U.S. Department of the Interior
BUREAU OF LAND MANAGEMENT

Well Name: POKER LAKE UNIT 30-19 BS	Well Location: T25S / R31E / SEC 30 / NENW /	County or Parish/State:
Well Number: 151H	Type of Well: CONVENTIONAL GAS WELL	Allottee or Tribe Name:
Lease Number: NMLC061634A	Unit or CA Name:	Unit or CA Number: NMNM71016X
US Well Number: 3001553536	Well Status: Approved Application for Permit to Drill	Operator: XTO PERMIAN OPERATING LLC

Procedure Description: ** Surface hole Change, First and Last Take Point Changes, Bottomhole Location Change, Drilling Plan Change, Casing/Cement Change XTO Permian Operating, LCC. requests permission to make the following changes to the original APD: No Additional Surface Disturbance Changing formation fr/ (98220) Purple Sage; Wolfcamp to (97913) Wildcat G-06 S253002O; Bone Spring SHL: fr/469'FNL & 1331'FWL to 755'FNL & 1649'FWL, FTP: fr/2310'FNL & 680'FWL to 2115'FNL & 405'FWL, LTP: fr/100'FNL & 680'FWL to 2489'FSL & 405'FWL, BHL: fr/50'FNL & 680'FWL to 2588'FSL & 405'FWL, Section 18-T25S-R31E Additionally, XTO Permian Operating, LLC. respectfully requests permission to upsize the casing design. The surface, intermediate and production hole, casing, and c

WELL LOCATION AND ACREAGE DEDICATION PLAT

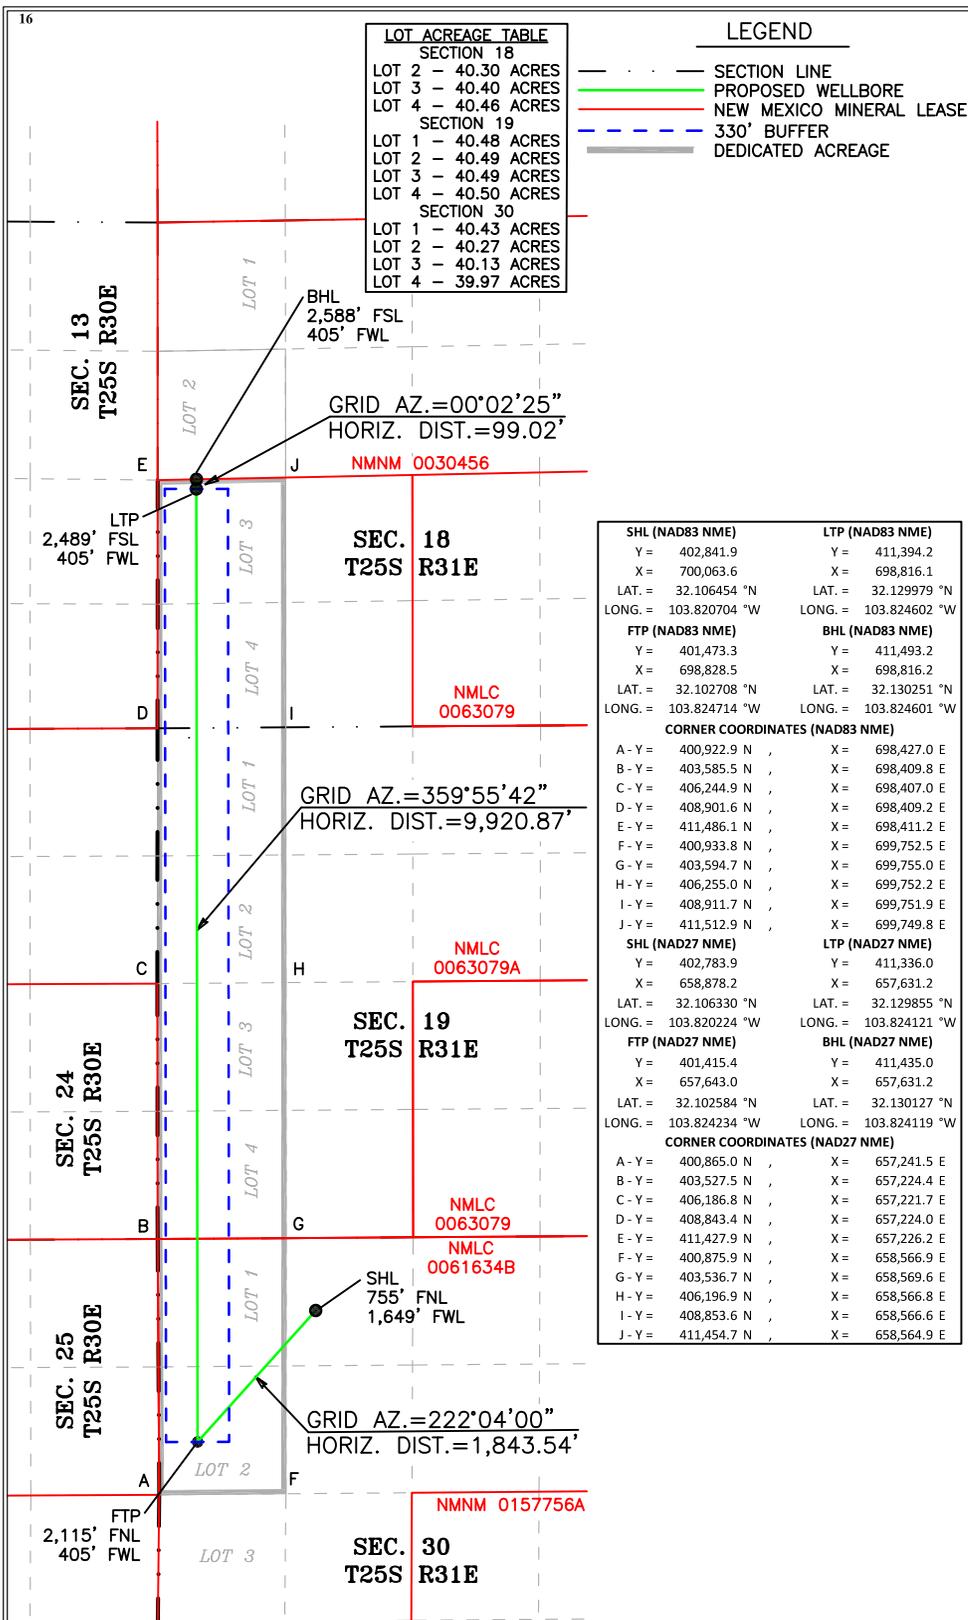
SHL: fr/469FNL & 1331FWL to 755FNL & 1649FWL,

FTP: fr/2310FNL & 680FWL to 2115FNL & 405FWL,

LTP: fr/100FNL & 680FWL to 2489FSL & 405FWL,

BHL: fr/50FNL & 680FWL to 2588FSL & 405FWL, Section 18-T25S-R31E

UL or lot no.	Section	Township	Range	Lot Idn	Feet from the	North/South line	Feet from the	East/West line	County
C	30	25 S	31 E		755	NORTH	1,649	WEST	EDDY

UL or lot no.	Section	Township	Range	Lot Idn	Feet from the	North/South line	Feet from the	East/West line	County
3	18	25 S	31 E		2,588	SOUTH	405	WEST	EDDY
